ADDENDUM #3

DATED: AUGUST 13, 2025

**PROJECT: Huxford Elementary School Gymnasium
And Classroom Addition For
Escambia County Board Of Education
Huxford, Alabama**

PH&J No: 2312SC

SECTION A
N.T.S. S2.2 1

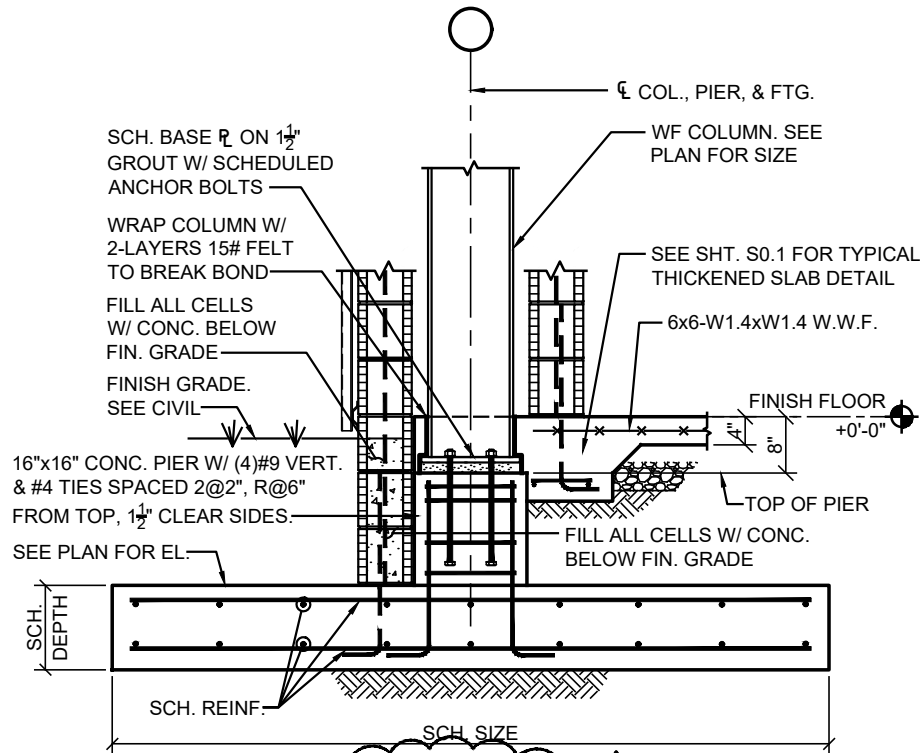
18. **Section Detail (Sheet S2.2)**: Revise Detail A/S2.2 as shown in the sketch contained herein as Addendum No.: 3; Attachment #6.
